**REZONING &
SUBDIVISION STAFF REPORT****Date: October 7, 2004****APPLICANT NAME**

Franklin Primary Health Center, Inc.

SUBDIVISION NAMEFranklin Primary Health Center Subdivision,
Resubdivision of**LOCATION****Subdivision:** 1303 Dr. Martin Luther King Jr. Ave.
(West side of Cuba Street, extending from Dr.
Martin Luther King Jr. Ave. to Lyons Street)**Rezoning:** Northwest corner of Lyons Street and
Cuba Street.**CITY COUNCIL
DISTRICT**

REQUEST Rezoning from R-3 to B-1, Subdivision

SITE PLAN

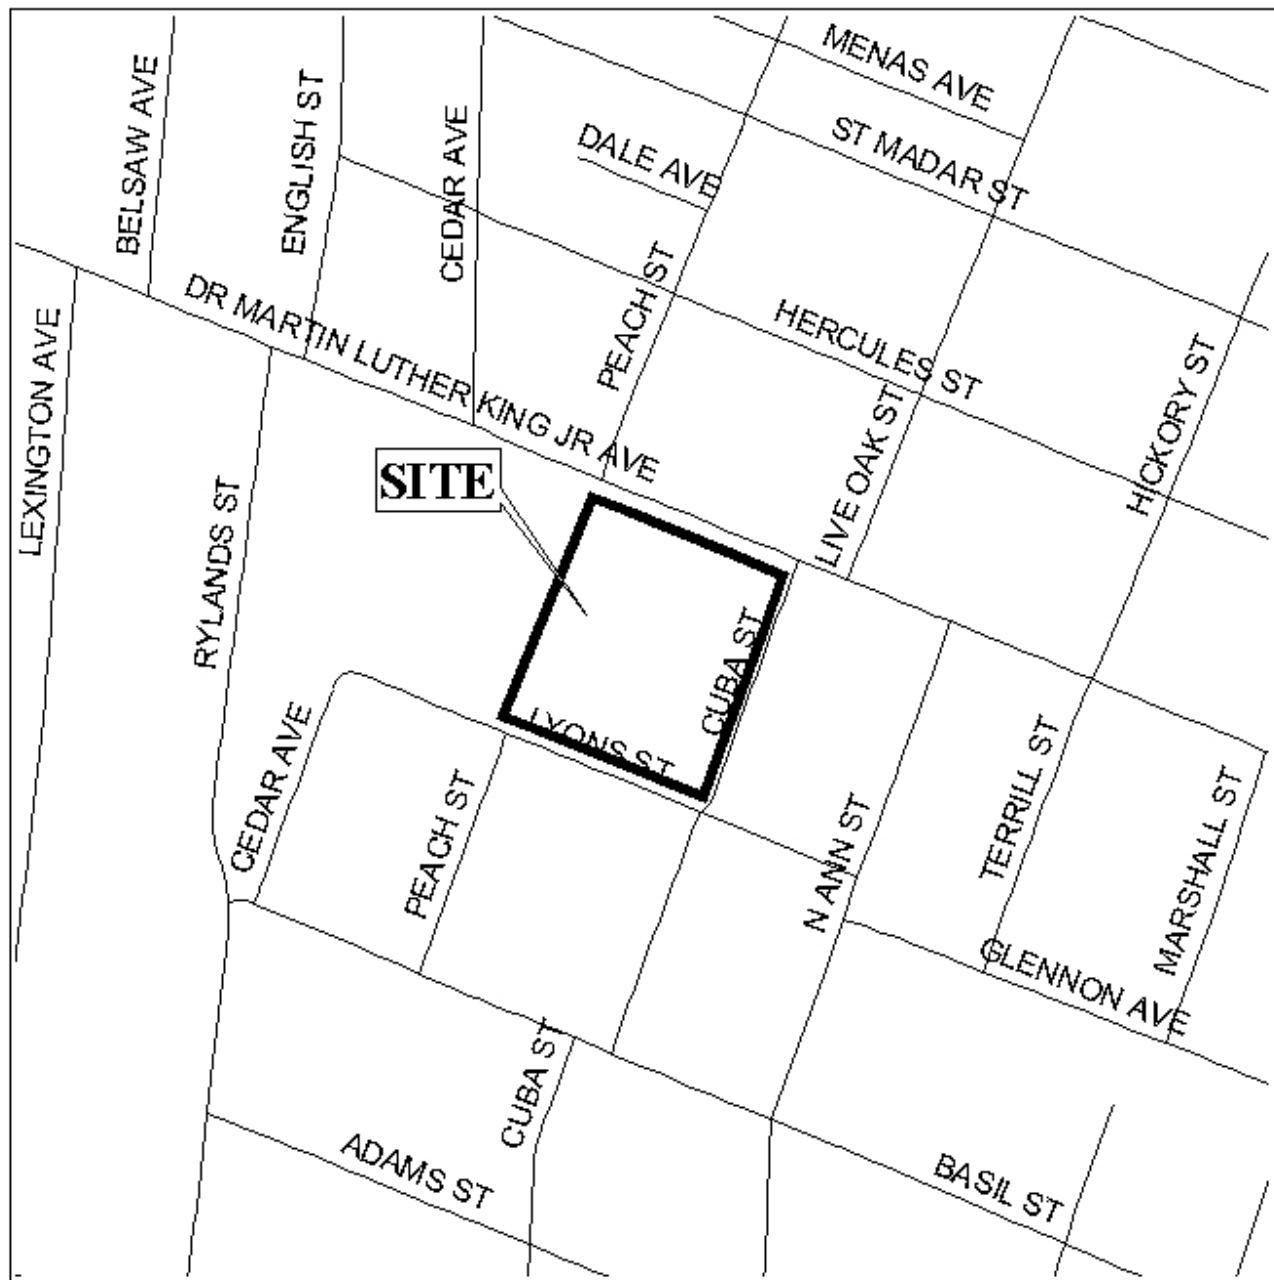
While the site may be appropriate for rezoning, there are concerns regarding buffering for the residential properties across Cuba Street and Lyons Street. The Zoning Ordinance requires that parking facilities located across minor streets from residential properties be screened from view with either an evergreen hedge or masonry wall, five and one-half feet tall, and setback five feet from the property line. The plan indicates a 6' aluminum fence on or near the Cuba Street and Lyons Street property lines. No further information was provided regarding the fence, however, based on the information provided, it does not appear that the fence will meet the requirements for screening as stated above.

Other conditions from the prior approvals that should be maintained (and reiterated) are denial of access to Lyons Street and limitations on curb cuts to Dr. Martin Luther King Jr Avenue. Also, due to the inclusion of the Cuba Street frontage, a limitation on the number of curb cuts would now be appropriate. The conditions will be best addressed through the Subdivision.

provision of screening of parking facilities as required by Section VI.3.i of the Zoning Ordinance; 2) completion of the subdivision process; and 3) full compliance with all municipal codes and ordinances.

Subdivision: the plat meets the minimum requirements of the Subdivision Regulations and is recommended for Tentative Approval subject to the following conditions: 1) completion of the rezoning process prior to recording of the final plat; 2) placement of a note on the final plat stating that access to Lyons Street is denied; 3) placement of a note on the final plat stating that access to Dr. Martin Luther King Jr Avenue is limited to a maximum of two curb cuts, size, location and design to be approved by the Traffic Engineering Department; and 4) placement of a note on the final plat stating that access to Cuba Street is limited to a maximum of two curb cuts, size, location and design to be approved by the Traffic Engineering Department.
